**TOLEDO - LUCAS COUNTY PLAN COMMISSIONS**

REF: PUD25-0003

SUBJECT: Planned Unit Development for multiple commercial buildings at 3450 W. Central Avenue

SHEET NAME: OVERALL SITE PLAN  
SHEET NO: C-201

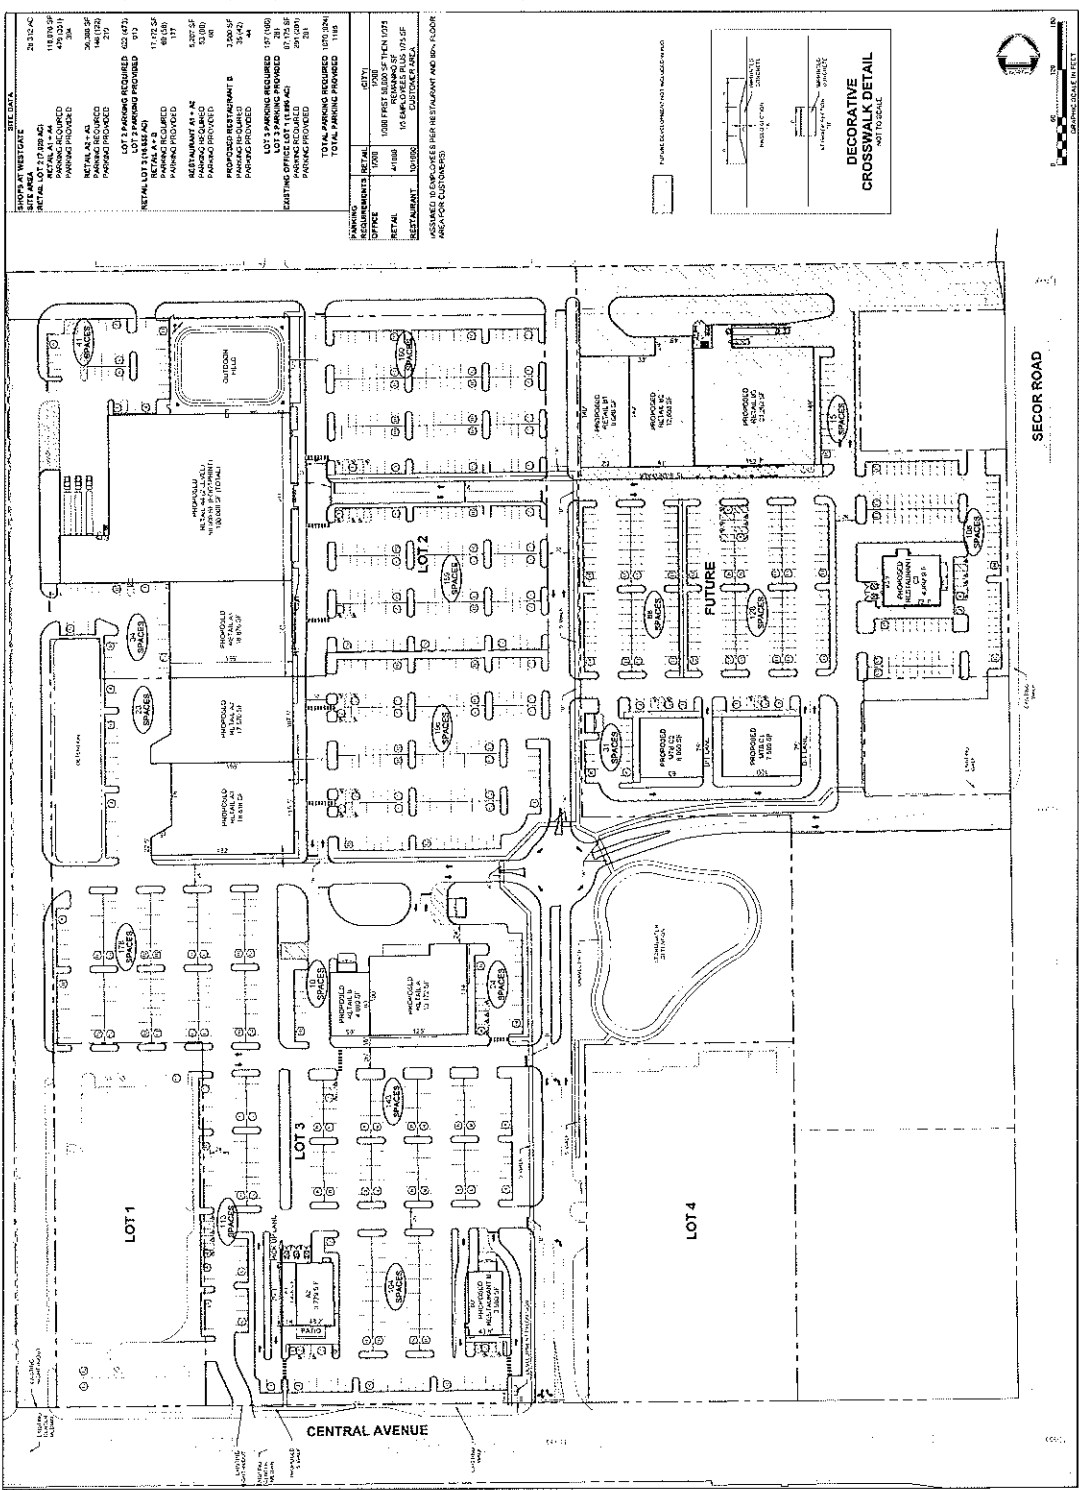
TMC§1107.1601 requires seven (7) vehicle stacking spaces for restaurant drive-throughs. Stacking spaces for the proposed drive-thru lanes have not been shown on the site plan as required by TMC§1107.1600. Stacking spaces must be a minimum of ten feet (10') by twenty feet (20') in size. Since these will be order-ahead pick-up windows without an order box, the applicant may provide dedicated pick-up spaces in lieu of vehicle stacking spaces. A condition of approval has been included that the applicant submit a revised site plan depicting stacking spaces and/or dedicated pick-up spaces.

Walkways within large-scale retail projects are required to connect focal points of pedestrian activity such as, but not limited to, transit stops, street crossings, building and store entry points, and shall feature items such as adjoining landscaped areas that includes trees, shrubs, benches, flower beds, planters, groundcover, or other such materials for no less than thirty percent (30 %) of its length. The proposed walkways attempt to achieve this requirement, but falls short in directly connecting Central Avenue to the Outparcel 1 and Anchor Retail buildings. There is also a lack of connection between store entrances, specifically between the existing office building, “Outparcel 1 Building”, “Multi-tenant Building”, and “Restaurant B / Outparcel 2” Building. Direct pedestrian walkway connections shall be added resolving these connection issues. This has been included as a condition of approval.

Sidewalks are required along both sides of all private streets – of which a few of the proposed drive aisles may be considered. Additional sidewalk connections are required along all sides of the roundabout. The Plan Commission is supportive of including sidewalk along only one side of the north-south drive aligned with the Central Avenue traffic light intersection and one side of the northern drive aligned with the Secor Road traffic light intersection.

42. Per TMC Sections 1103.1010 & 1109.0304, a direct pedestrian walkway connection shall be added between Central Avenue, the "Outparcel 1 Building" entrance(s), and the "Anchor Retail" building entrance(s). Subject to the approval of the Plan Director. **Not acceptable as depicted. The applicant shall submit a revised site and landscaping plan to the Plan Director depicting this required pedestrian walkway connection.**

43. Per TMC Sections 1103.1010 & 1109.0304, direct pedestrian walkway connections shall be added between the existing office building, the "Outparcel 1 Building", the "Multi-tenant Building", and the "Restaurant B / Outparcel 2 Building". Subject to the approval of the Plan Director. **Not acceptable as depicted. The applicant shall submit a revised site and landscaping plan to the Plan Director depicting these required pedestrian walkway connections.**

44. Sidewalks are required along all sides of the roundabout, on one side of the north-south drive aligned with the Central Avenue traffic light intersection, and along one side of the northern drive aligned with the Secor Road traffic light intersection, subject to the approval of the Plan Director. **The applicant shall submit a revised site and landscaping plan to the Plan Director.**

SHEETNAME: OVERALL LANDSCAPE PLAN  
SHEET NO: L-300

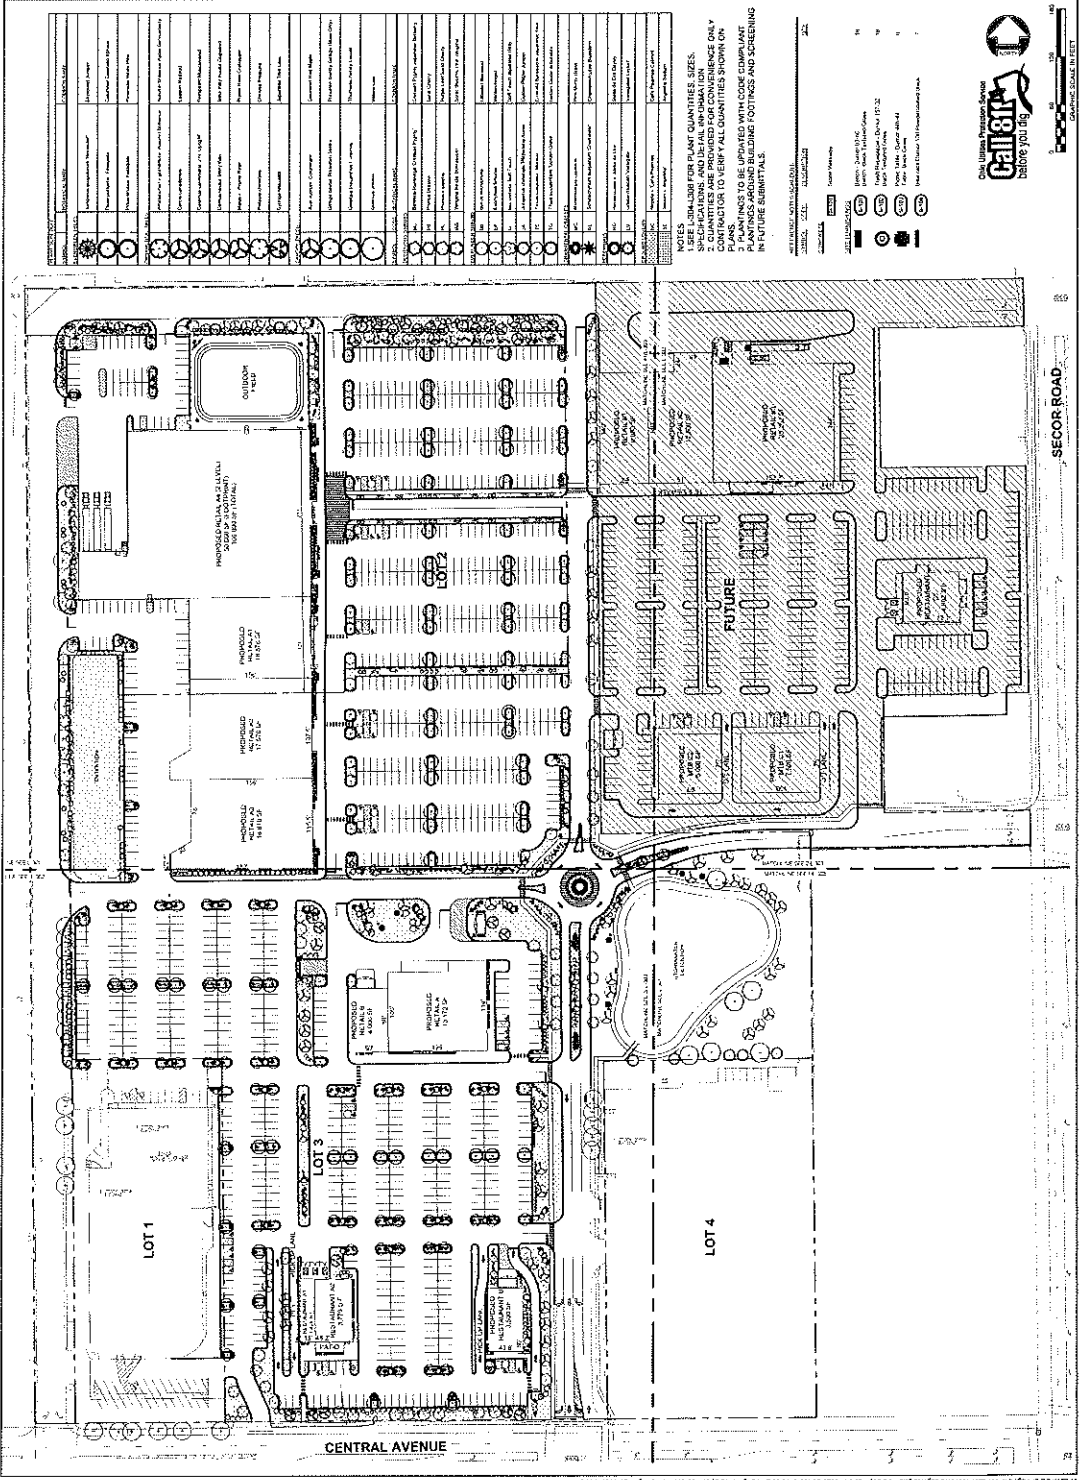
In addition to open space requirements, PUD's are required to meet the landscape and screening requirements of TMC§1108. A minimum thirty-foot (30') wide frontage greenbelt along Central Avenue is required per TMC§1108.0202. This greenbelt must contain at least one (1) tree for every thirty-feet (30') of frontage. A minimum of twenty-four (24) trees are required along Central Avenue. The tree planting plan depicts fourteen (14) trees along Central Avenue. The plan identifies six (6) additional existing trees to remain, but those are within the right-of-way and cannot count toward frontage greenbelt requirements per TMC§1108.0202(A). An additional ten (10) trees shall be provided on the landscaping plan and listed as a condition of approval.

Buffer and screening requirements are required per TMC§1108.0203. A Type “B” Buffer is required along the western property line. The Type B Buffer requires four (4) canopy trees and fifteen (15) shrubs per 100 linear feet. In total sixty (60) canopy trees and 225 shrubs are required along the western property line. The landscaping plan depicts thirty-one (31) trees and ±149 shrubs on the opposite side of an existing drive aisle as the applicant is requesting a waiver of the PUD perimeter open space requirement in this area. The Plan Commission has recommended approval of this waiver to permit the existing western drive aisle to remain. As such, a condition of approval has thus been included that a revised landscaping plan be submitted depicting a minimum of sixty (60) canopy trees and 225 shrubs on the opposite side of the western drive aisle.

The submitted landscaping plan includes 287 trees and ±862 shrubs on the interior of the site, whether interior to the parking lot areas, within drive medians, or in the consolidated open space. Between parking lot interior requirements and site interior requirements, 368 trees and 711 shrubs are required. A condition of approval has been included that a revised landscaping plan be submitted in compliance with these applicable sections. The Plan Commission recommends that the Plan Director be permitted to modify this condition to reduce the required number depending on how many materials can be reasonably planted given the available landscaping areas. This has been included within the condition.

36. Usable, accessible, and consolidated common open space areas in the amount of no less than ten percent (10%) of the gross site acreage is required per TMC§1103.1008(C). **Not acceptable as depicted. The applicant shall submit a revised site and landscaping plan showing compliance with TMC§1106.1008(C).**

48. Per TMC§1108.0202, a minimum thirty-foot (30') wide frontage greenbelt along Central Avenue is required. This greenbelt must contain at least one (1) tree for every thirty-foot (30') of frontage. **Not acceptable as depicted. A revised landscaping plan shall be submitted to the Plan Director depicting a minimum of twenty-four (24) trees within the Central Avenue frontage greenbelt.**

49. Per TMC§1108.0203, a Type B landscape buffer is required along the western property line. Four (4) canopy trees and fifteen (15) shrubs are required within the buffer per 100 linear feet. Type B landscape buffer materials may be placed on the opposite side of the western drive aisle. May be modified by the Plan Director. **Not acceptable as depicted. The applicant shall submit a revised landscape plan to the Plan Director depicting a minimum of sixty (60) canopy trees and 225 shrubs.**

52. In addition to other landscape requirements for buffer areas, frontage greenbelts, and parking lot perimeters, 368 trees and 711 shrubs are required between the parking lot interior requirements of TMC§1108.0204 and the site interior requirements of TMC§1108.0205(B). Condition may be modified by the Plan Director. **Not acceptable as depicted. The applicant shall submit a revised landscaping plan to the Plan Director.**

# "ANCHOR BUILDING" - NORTHERN SECTION

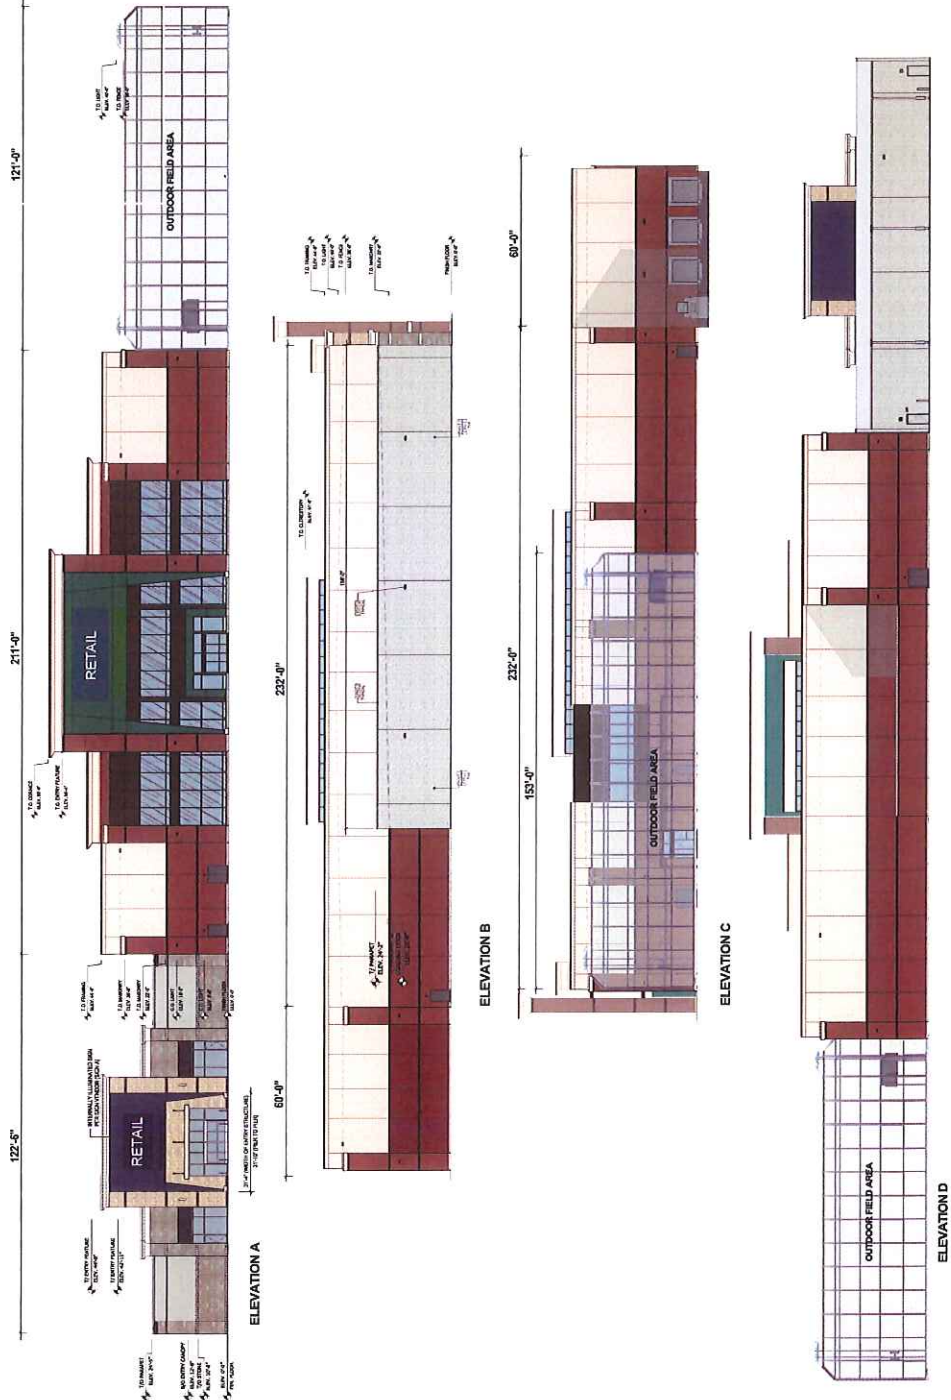
The northern portion of the anchor building has one (1) elevation visible from the right-of-way: the eastern elevation. The materials of this elevation are not spelled out, but it appears the elevation is comprised of roughly sixty-five percent (65%) predominant materials (masonry, windows, and architectural metal) and thirty-five percent (35%) accent materials (EIFS or stucco). As a condition of approval, the applicant shall submit revised elevation drawings with materials specified and showing compliance with TMC§1109.0500.

- b. **The northern portion of the "Anchor Building" is not acceptable as depicted. The applicant shall submit revised elevation drawings to the Plan Director with a percentage material break down showing compliance with TMC§1109.0500.**
